**PD Modification Application: MM 26-0441**

**Applicant:** Riverview Montessori School at Rivercrest, LLC

## AGENCY REVIEW COMMENT SHEET

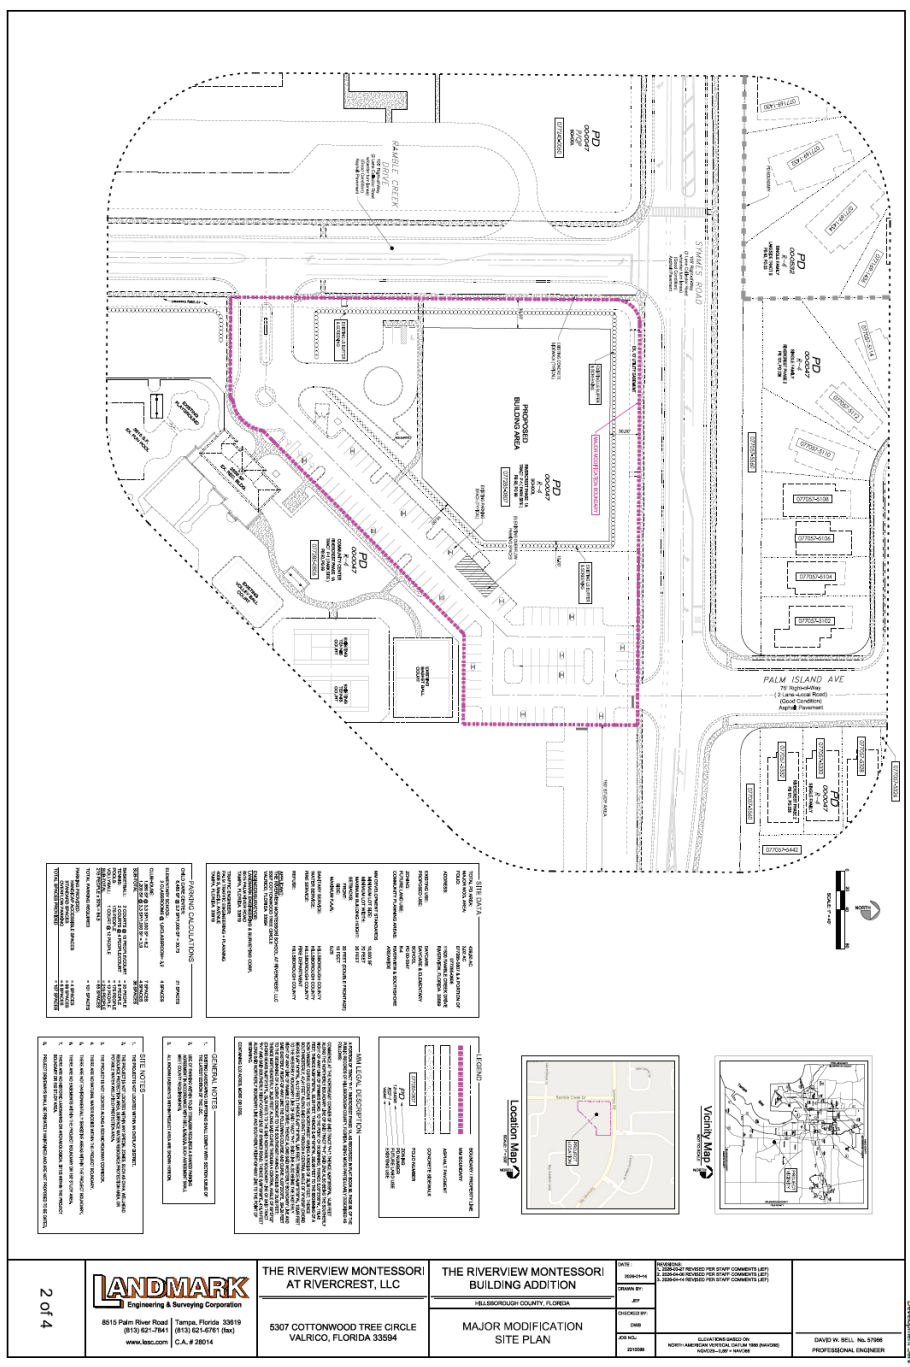
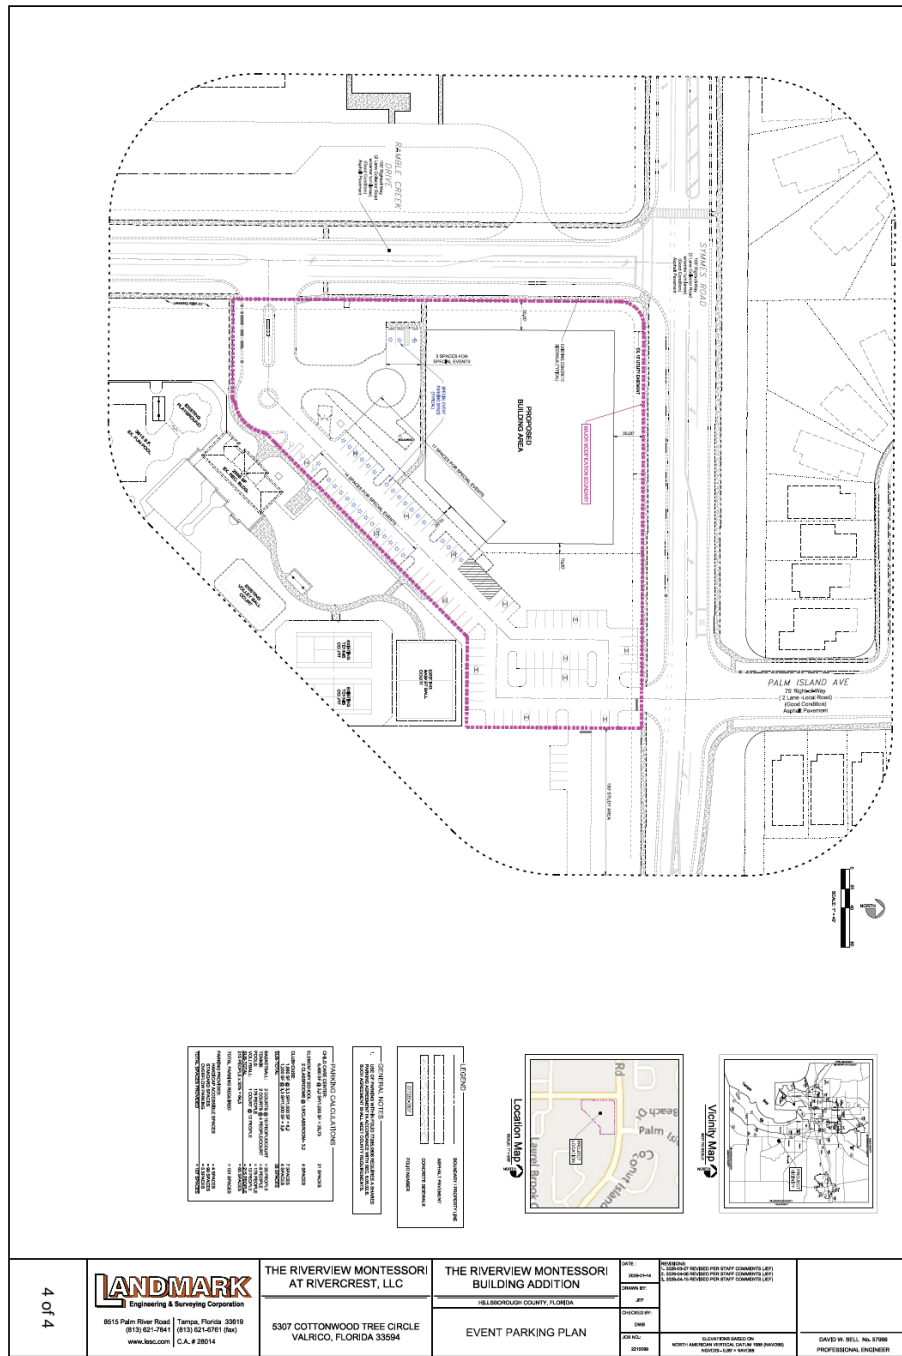
1. First sheet to match the certified site plan for PRS 15-0130.
2. Add a site plan (sheet 2 of 4) showing the modification area. On that sheet:
  - a. Include the Site Data Table, General Notes, and revised Legal Description from other sheets, correcting the existing use data to match approved uses for this area of Pocket M as shown on the approved plan (file 15-0130).
  - b. Add a proposed use table which states:
    - 6,480 g.s.f. max. of Child Care Center Uses (80 students maximum)
    - 26,407 g.s.f. max. of Private School (grades K-5, 50 students maximum, 2 classrooms maximum)
  - c. Revise parking table to reflect LDC parking requirements. Correct parking calculation table to show the following:

3. Replace General Note 4 with a note reading "The traffic monitoring staff within the parking field shall hold cars from proceeding to the drop-off point and otherwise manage traffic flow (consistent with the Vehicle Queuing and Circulation Plan) as necessary to ensure the flow of traffic is safely managed, the exit to Ramble Creek Dr. remains reachable, and no accessible parking spaces are blocked within the MM 26-0441 modification area."
4. Rename Sheet 3 of 4 (Vehicle Queuing and Circulation Plan) and make the Event Parking Plan Sheet 4 of 4. Remove Site data table and site notes from these sheets.

- 5. On Sheet 3 of 4 add the required monitoring note in a prominent box stating, “Annually, at the beginning of each school year during the fourth week of class, the developer (at its sole expense) shall conduct traffic monitoring to access the sufficiency of queuing both on-site and off-site at the project access points. Such report shall be submitted to the Hillsborough County Development Service and Public Works Departments. This annual monitoring requirement shall remain in effect for one (1) year beyond the time the total enrollment reaches 50 students. In the event that significant offsite queuing of vehicles at arrival or dismissal times is found, the school shall be required to submit corrective measures, which could include revised staggered start and ends times, staggered arrival/departure times and/or a revised onsite circulation plan to alleviate off-site queuing. Such revised plan shall be subject to review and approval by Hillsborough County Public Works.”

- 6. On Sheet 3 of 4, revise label reading “School Patrol” to instead state “Traffic Monitoring Staff”.
- 7. On Sheet 3 of 4, add the following note regarding drop-off and pick-up times to the plan:  
Grade K-5 Drop Off and Pick-up Times as Follows:

# OPTION 2

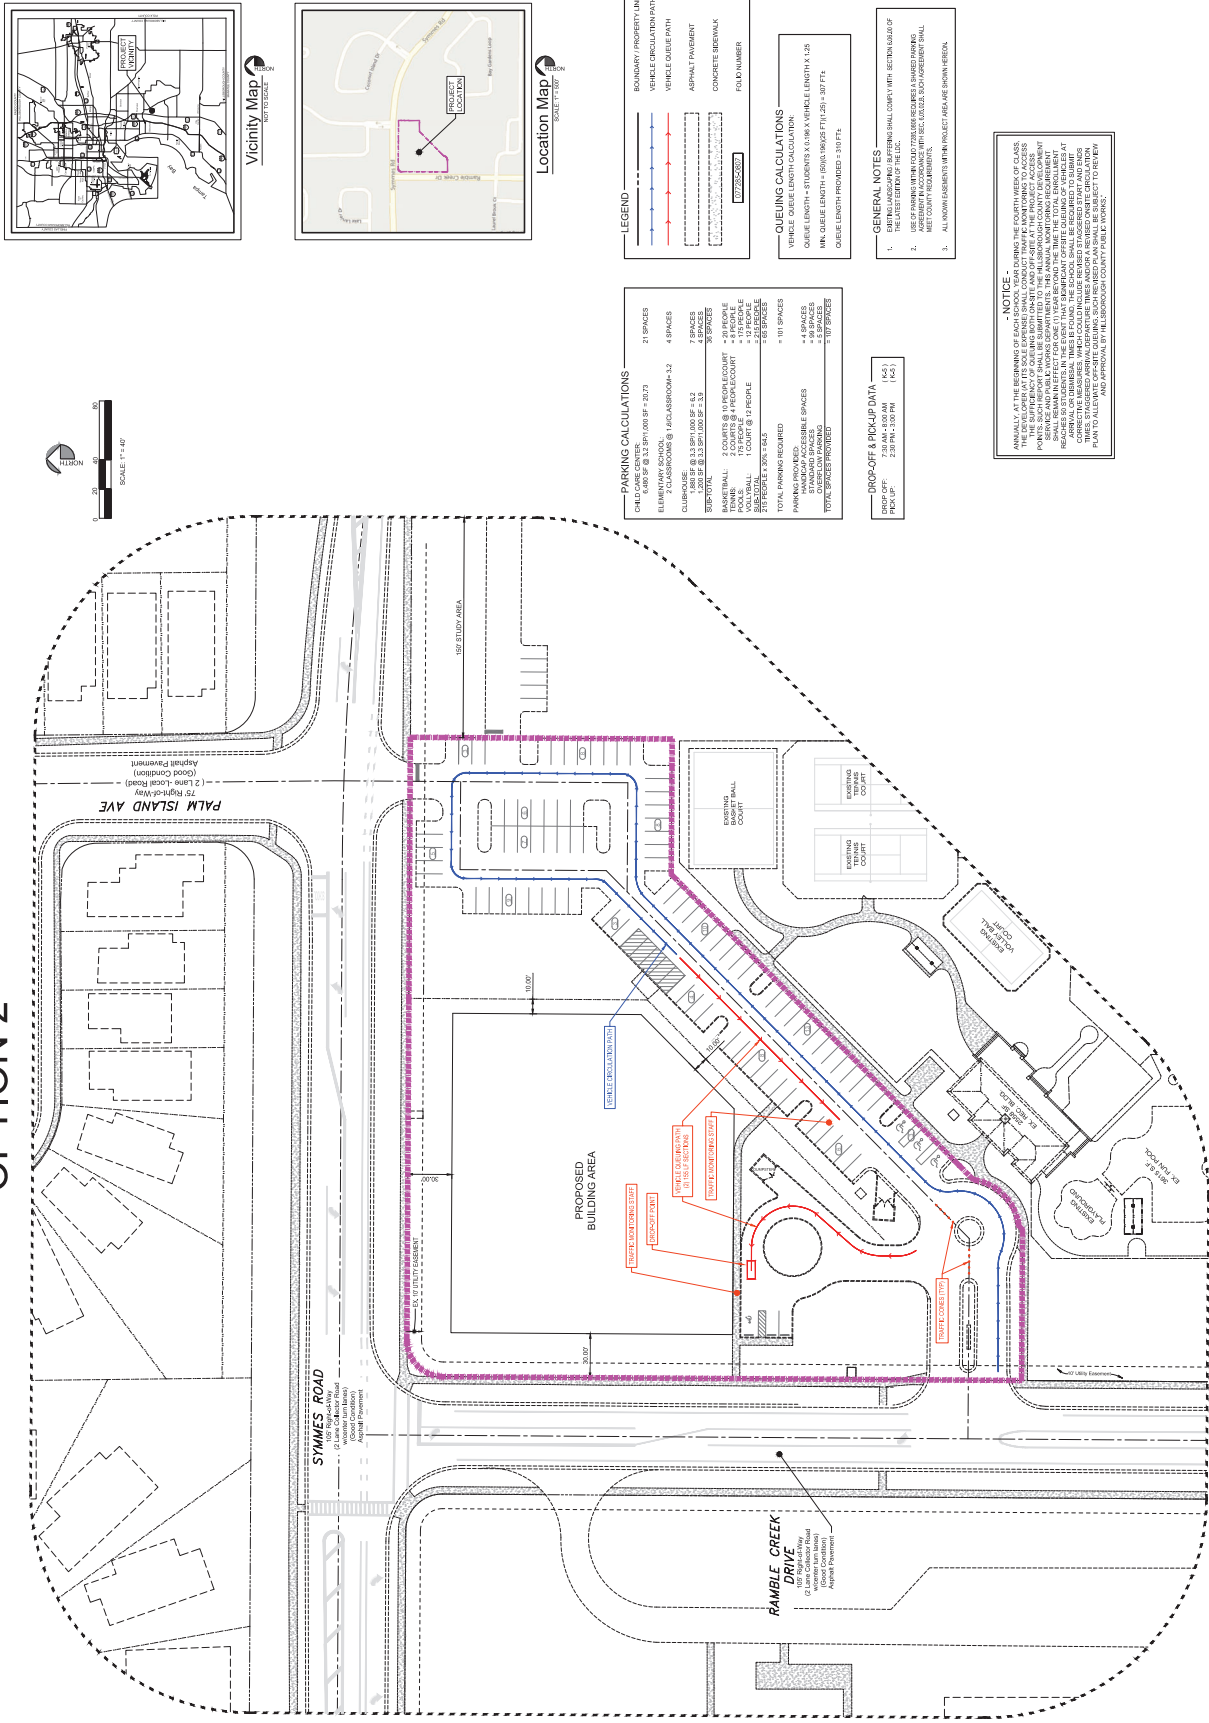
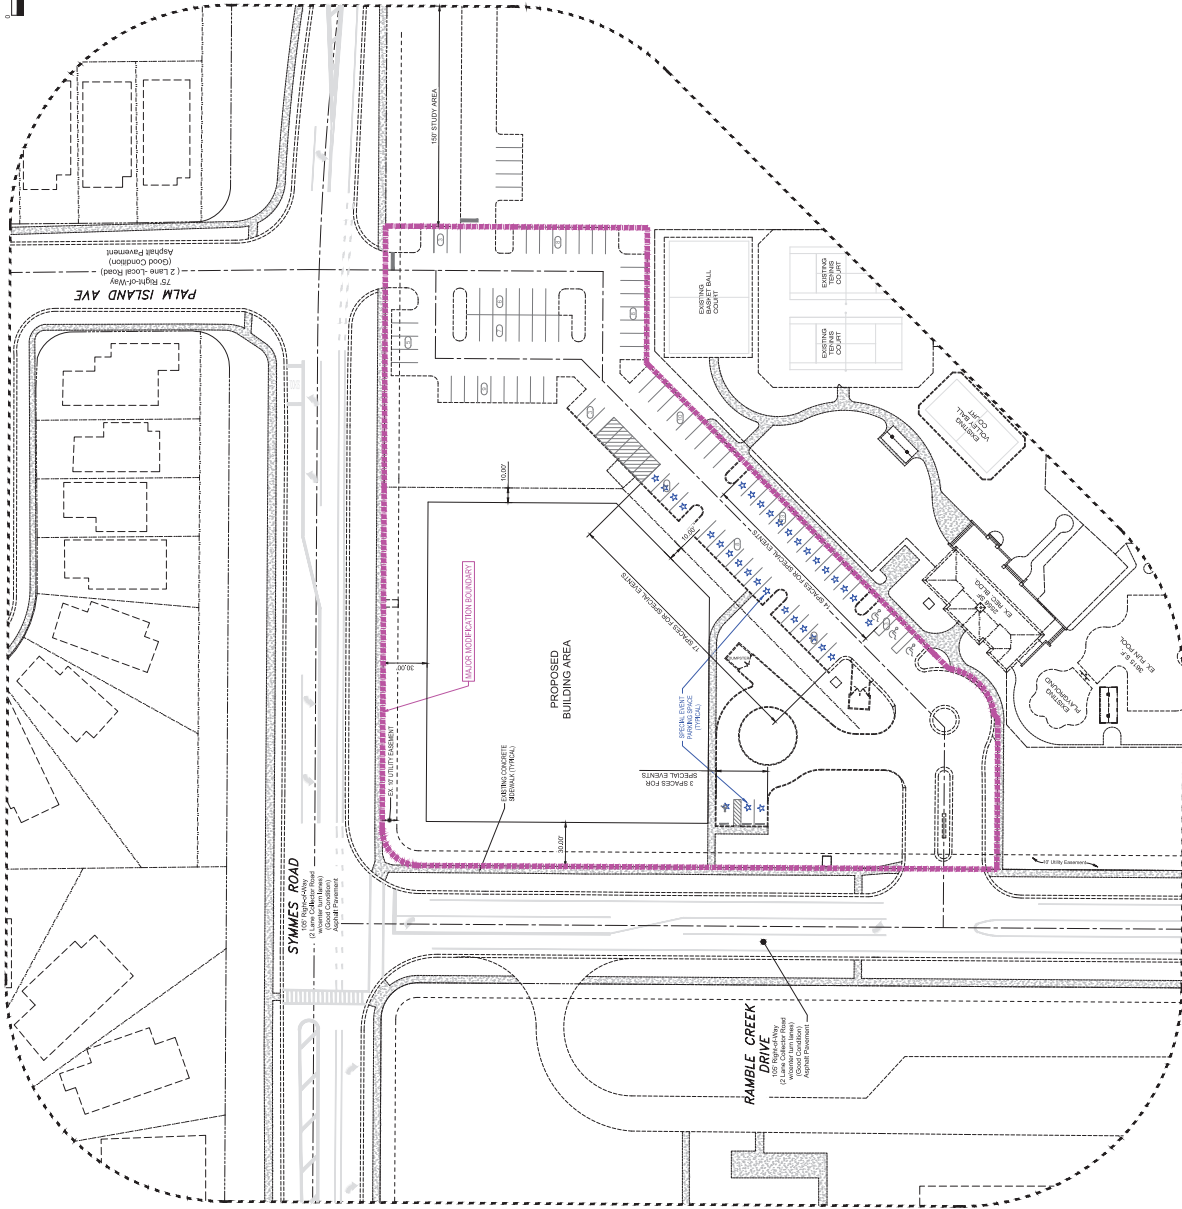
Prior to Site Plan Certification the applicant shall revise the site plan received April 7, 2026 to:

- Add a site plan (sheet 2 of 4) showing the modification area. On that sheet:
  - Include the Site Data Table, General Notes, and Legal Description from other sheets, correcting the existing use data to match approved uses for this area of Pocket M as shown on the approved plan (file 15-0130).
  - Add a proposed use table which states:
    - 6,480 g.s.f. max. of Child Care Center Uses (80 students maximum)
    - 26,407 g.s.f. max. of Private School (grades K-5, 50 students maximum, 2 classrooms maximum)
  - Revise parking table to reflect LDC parking requirements. Correct parking calculation table to show the following:

- Replace General Note 4 with a note reading “The traffic monitoring staff within the parking field shall hold cars from proceeding to the drop-off point and otherwise manage traffic flow (consistent with the Vehicle Queuing and Circulation Plan) as necessary to ensure the flow of traffic is safely managed, the exit to Ramble Creek Dr. remains reachable, and no accessible parking spaces are blocked within the MM 26-0441 modification area.”

- Rename Sheet 3 of 4 (Vehicle Queuing and Circulation Plan) and make the Event Parking Plan Sheet 4 of 4. Remove Site data table and site notes from these sheets.

- On Sheet 3 of 4 add the required monitoring note in a prominent box stating, “Annually, at the beginning of each school year during the fourth week of class, the developer (at its sole expense) shall conduct traffic monitoring to assess the sufficiency of queuing both on-site and off-site at the project access points. Such report shall be submitted to the Hillsborough County Development Service and Public Works Departments. This annual monitoring requirement shall remain in effect for one (1) year beyond the time the total enrollment reaches 50 students. In the event that significant offsite queuing of vehicles at arrival or dismissal times is found, the school shall be required to submit corrective measures, which could include revised staggered start and ends times, staggered arrival/departure times and/or a revised onsite circulation plan to alleviate off-site queuing. Such revised plan shall be subject to review and approval by Hillsborough County Public Works.”

- On Sheet 3 of 4, revise label reading “School Patrol” to instead state “Traffic Monitoring Staff”.
- On Sheet 3 of 4, add the following note regarding drop-off and pick-up times to the plan:
